Potential Change Order / Construction Field Directive

To: Project:	Rick Moore with Overaa Construction, Inc. PCO # 05 Agriculture Science Horticulture Project					
Additional Design Services for Non-Conforming Work Description of Work:						
Per CCD-016 – Fill Green Screen Fence 2-7/8 inch posts with 4,500 PSI concrete to correct non-conforming installation.						
Reason for I	Directive:	2 :				
Overaa to pr Direction:	rovide credit in the amount of \$6,0	82 to the District.				
Provide credit for above amount.						
Proceed with work, based on approved lump sum change amount						
Proceed with work on T&M Basis, submit T&M back-up daily						
Proceed with work, merit of change to be determined, sumit T&M back-up weekly						
Proceed with work, work is considered in scope of contract						
ву	rra -Construction Manager N WWW -Project Planner, Manager	7 · 24 · 22 Date 7 · 29 - 2000 Date

Subject: Las Positas College Horticulture Facility - Add Service Request 08-R1

DOA documents reference	d within this form are available to	JII LIIE DOAT	or box i dolications w	enpages.			
1. SUBMITTAL TYPE:	(Is this a resubmittal? Yes N	lo🔽)					
Deferred Submittal	Addendum Number:	Revision Number:

S-500

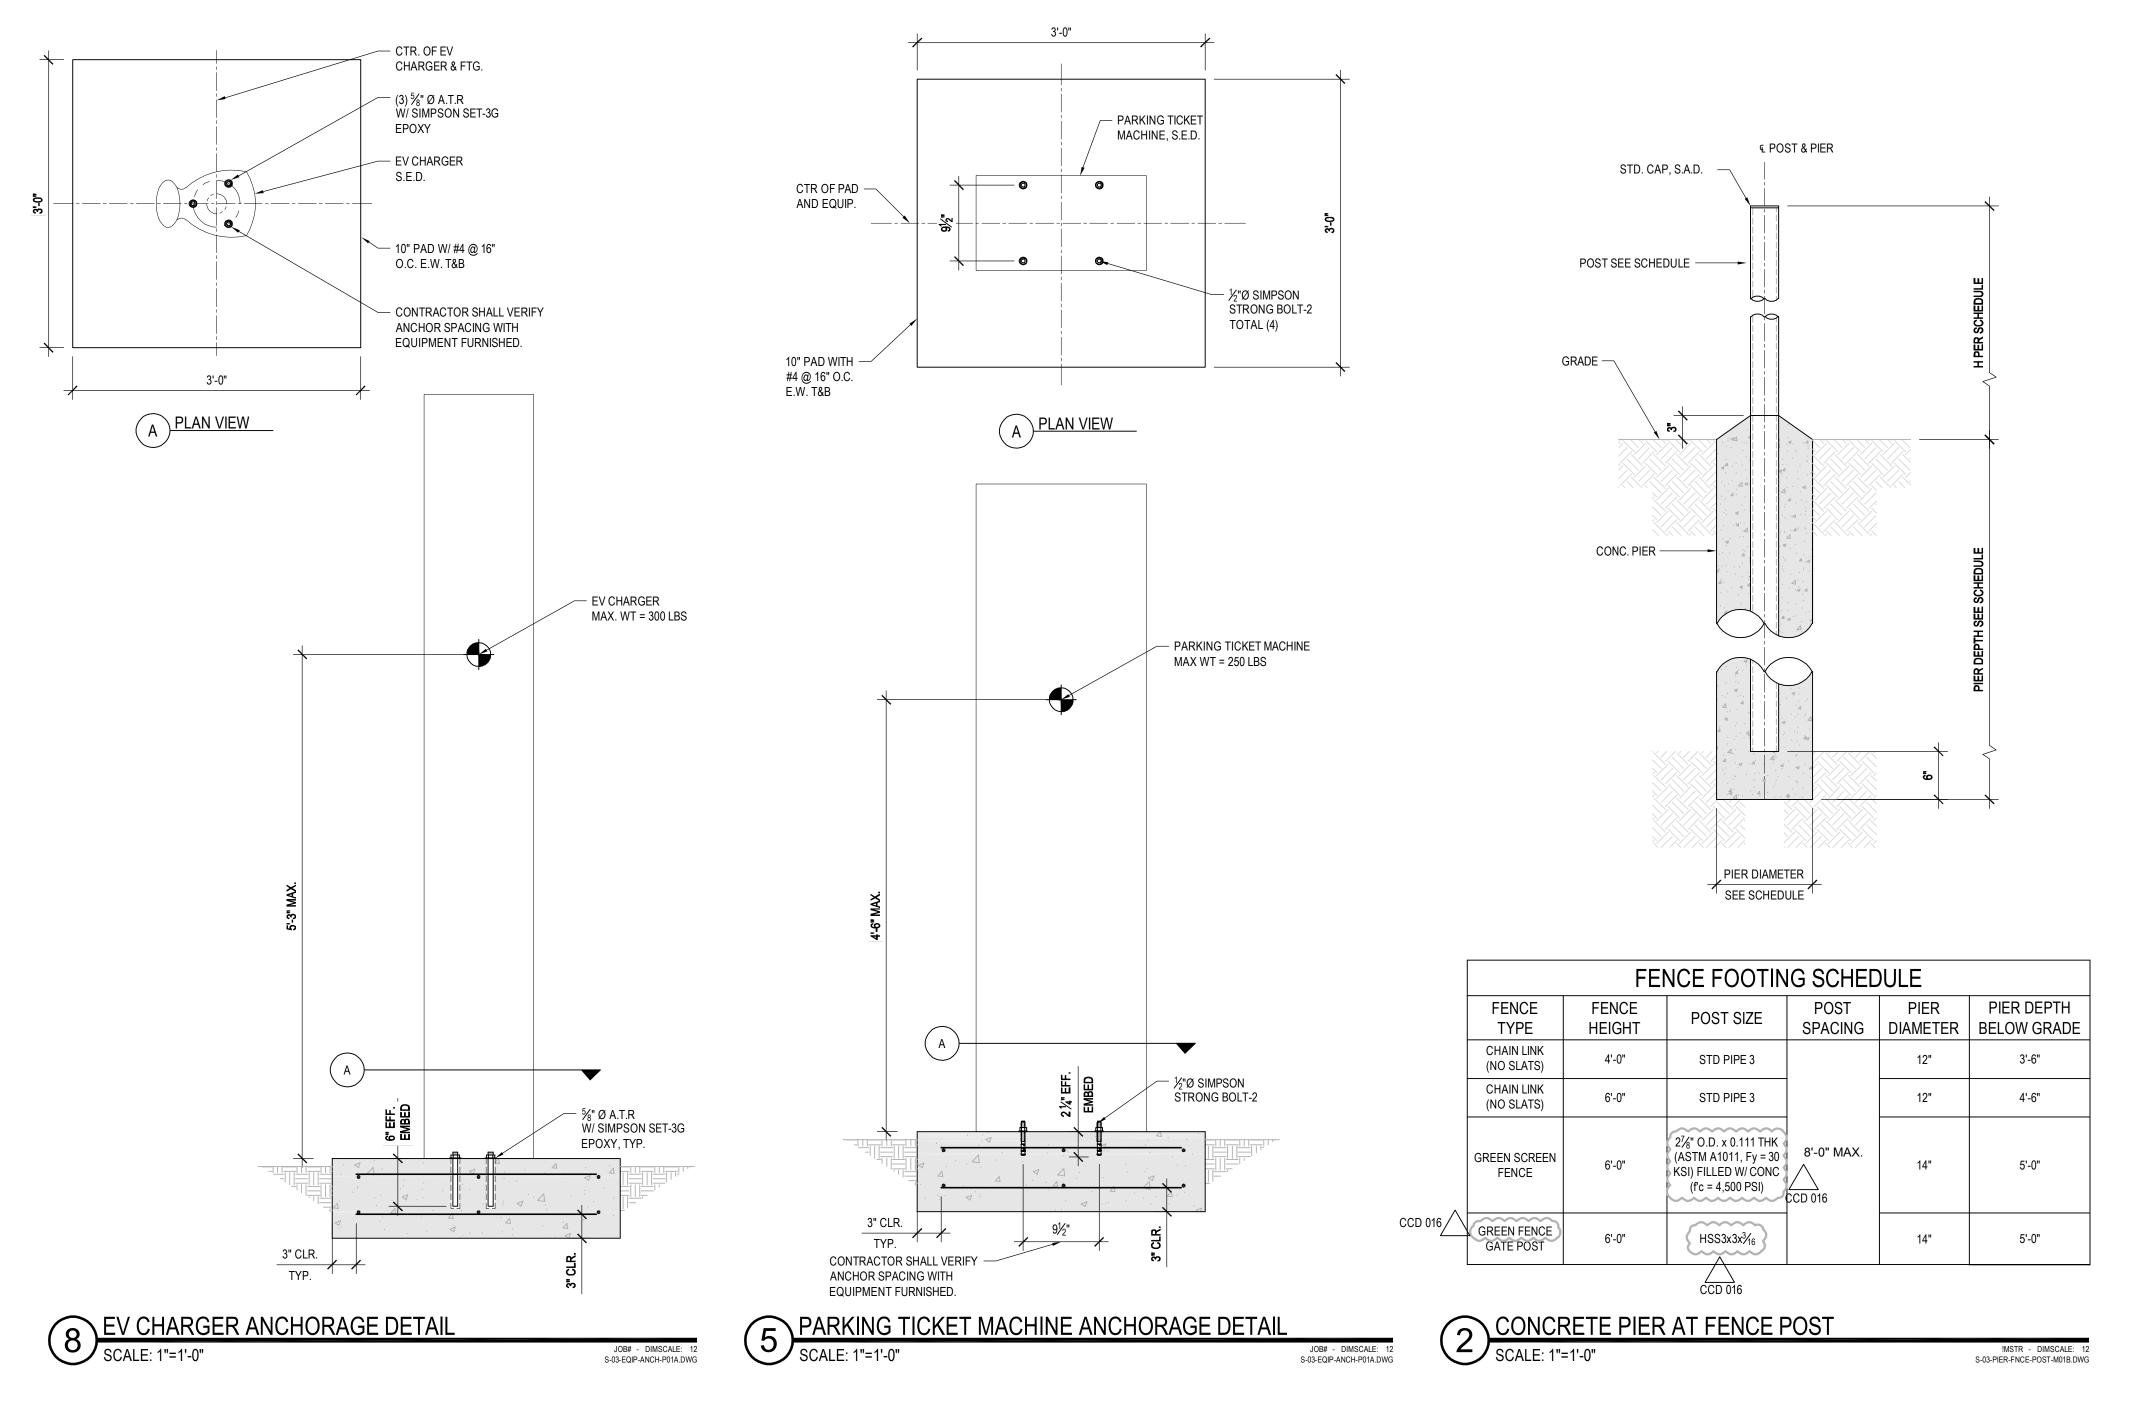
AC Martin has been advised that installed Greenscreen fence and gate posts do not conform to DSA approved design. Structural detail 2/S-500 indicated 3"x3"x1/4" square fence posts and either 3"x3"x1/4" square post or STD 3 round pipe at gates (.216" thick). Reviewed comments on shop drawing submittal #53 reiterated reference to 2/S-500 for post sizing and further clarified to use square posts at gates. We understand that 3'' round $x \frac{1}{8}''$ (.111" thick) fence posts and 3"x3"x3/16" gate posts are installed. We propose to assist with this issue as follows:

- 1. Prepare structural calculations to justify that installed 3"x3"x3/16" gate posts meet structural requirements for wind load.
- 2. Perform structural calculations to verify if installed round 3"x.111" fence posts meet wind load requirements.
- 3. Should the installed posts are not acceptable, perform structural calculations to verify if fully grouted posts will meet wind load requirements.
- 4. If structural calculations support use of installed posts, grouted or not, prepare CCD for DSA review and approval.
- 5. Project management and coordination of this nonconforming item.
